Blocks 2 & 3

Levels

Proposed Changes

Blocks 2 & 3 Overview

Block 3

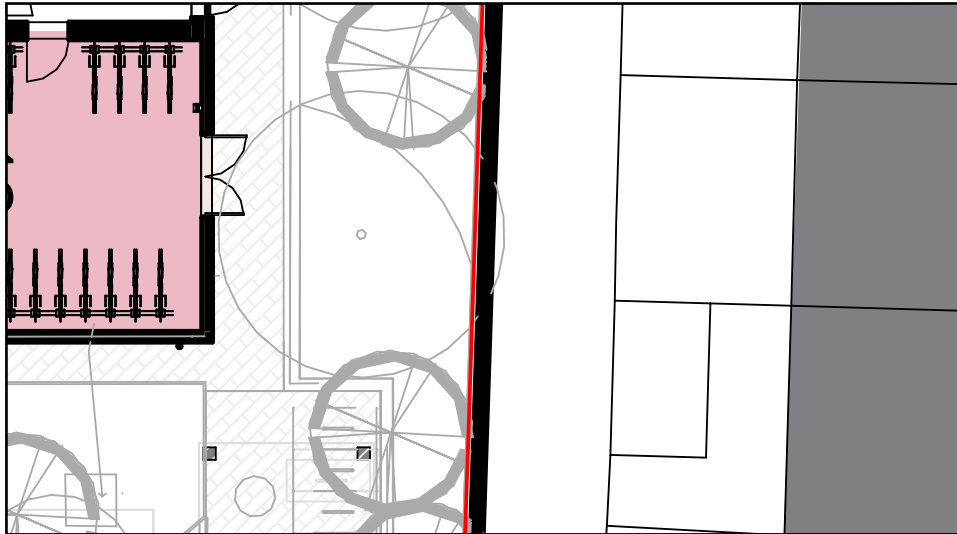
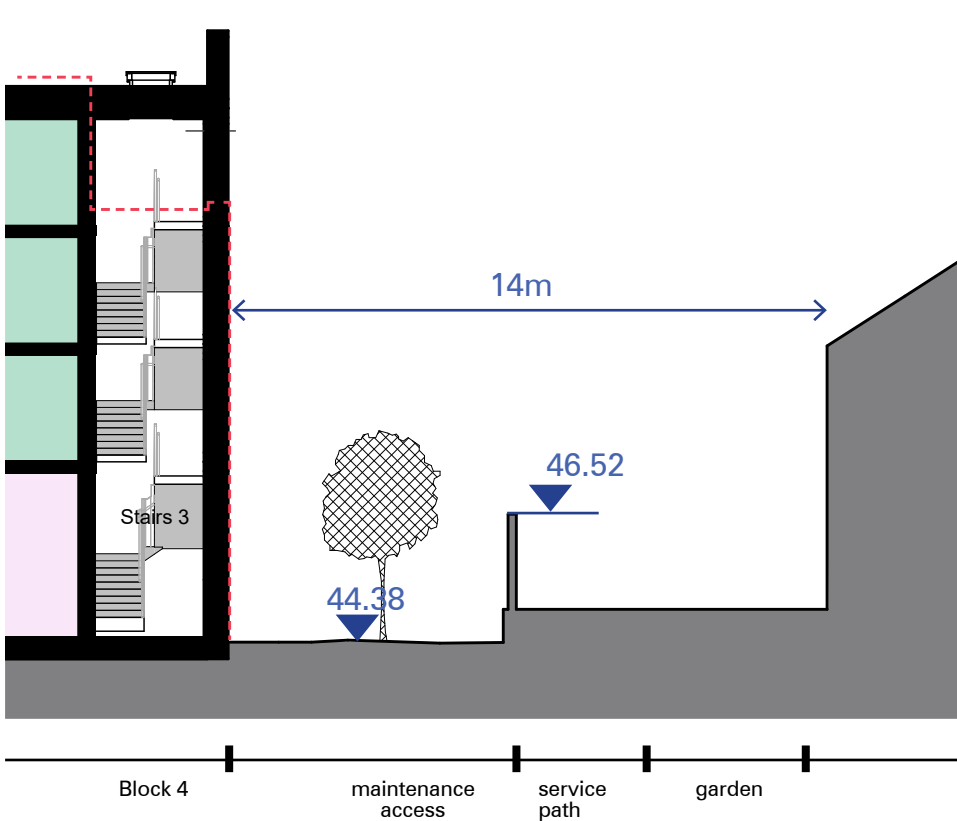
To facilitate the fire egress, a raised path is to be constructed. This extends to the door of the fire escape and runs along the rear of Block 3. As is shown on the revised planning drawings, a low level gate is proposed at either end which is on a sprung closer opening out from the means of escape. This gate restricts access to this path for residents. It defines what is publicly accessible and what is private space. The space will be CCTV monitored and residents will not be able to use this path, except in emergencies.

The raised path sits almost 1.7m lower than the top of the existing wall. The distance between Block 2 and the rear of the neighbouring building on Chelford Close is almost 13m. Mature Acer Campestre are proposed along this rear extent which will limit any direct overlooking.
